ADDENDUM NO. 2

Solicitation No.: Request For Proposal (RFP) No. 2019-00023- Step 2

Solicitation Title: City of Stockbridge, General Contractors- Amphitheater

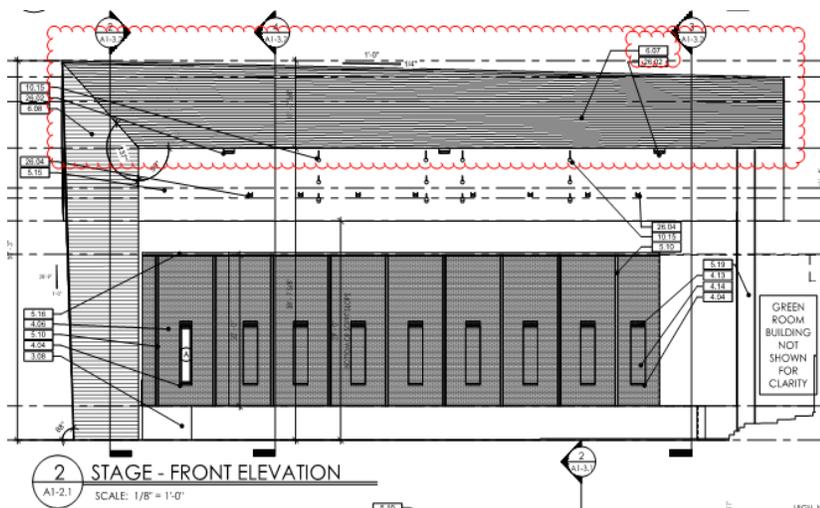
Q37. Confirm that the area marked in the red cloud the TRESPA will be applied horizontal and not vertical as it is mentioned in the note 6.07

A37. Confirmed, keynote revised to 6.08 with horizontal siding in Construction Document Addendum 2.
